Access Compliance Report Public Rights-of-Way (Curb Ramps)

Main Street: MAIN_ST Cross Street: N/A Location: E

ADA ID: RPRK211029131049 Ramp Type: Type 4 - Parallel Initial Pass/Fail: Pass Overall Compliance: No Severity Score: 26

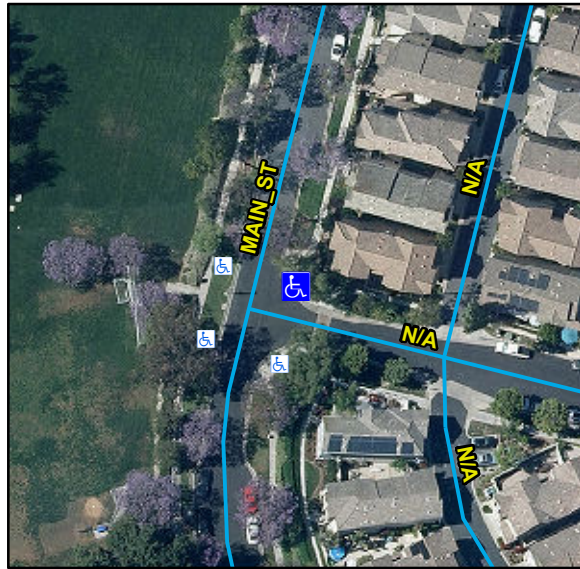
Compliance	Description	Data	Compliance	Description	Data
N/A	Ramp Length LT (in)	107	N/A	Ramp Length RT (in)	107
Yes	Ramp Width LT (in)	90	Yes	Ramp Width RT (in)	90
Yes	Ramp Run Slope LT (%)	7.4	Yes	Ramp Run Slope RT (%)	1.5
No	Ramp Cross Slope LT (%)	2.5	No	Ramp Cross Slope RT (%)	2.7
N/A	Landing Present	No	No	DWS Provided	No
N/A	Landing Length (in)	N/A	N/A	DWS Contrast	N/A
No	Landing Width (in)	N/A	N/A	DWS Length (in)	N/A
No	Landing Run Slope (%)	N/A	N/A	DWS Full Width	N/A
No	Landing Cross Slope (%)	N/A		DWS Offset Type	N/A
N/A	Landing Movement Obstructed?	No	N/A	DWS Offset Left (in)	N/A
	Landing Movement Type	Curb	N/A	DWS Offset Right (in)	N/A
N/A	Landing Shared	N/A			
N/A	Clear Space	Yes			
N/A	Clear Space To Crosswalk (in)	48			
N/A	Marked Crosswalk 1	No	N/A	Marked Crosswalk 2	No
	Crossing 1 Direction	NW		Crossing 2 Direction	SW
	Marked Crosswalk 1 Width (in)	N/A		Marked Crosswalk 2 Width (in)	N/A
N/A	Ramp Inside Crosswalk 1	N/A	N/A	Ramp Inside Crosswalk 2	N/A

Crossing 1 Slope (%)	0.2		Crossing 2 Slope (%)	1.9
	Crossing 1 Cross Slope (%)	3		Crossing 2 Cross Slope (%)	1.9
Yes	Gutter Ponding	No	N/A	Curb Slope	5.1
Yes	Gutter Lip Height (in)	0		Road Run Slope (%)	2.7
No	Gutter Run Slope (%)	7.6		Road Cross Slope (%)	0.3
No	Gutter Cross Slope (%)	3.2	No	Perpendicular Joint Present	No
Yes	Overall Surface Condition	Acceptable			
	Cross Gutter Present?	No		Spandrel Present?	No
	Replace Cross Gutter?	N/A		Replace Spandrel?	N/A

Remove & Replace Curb Ramp With Two New Directional Ramps or Equivalent. Remove & Replace Gutter.
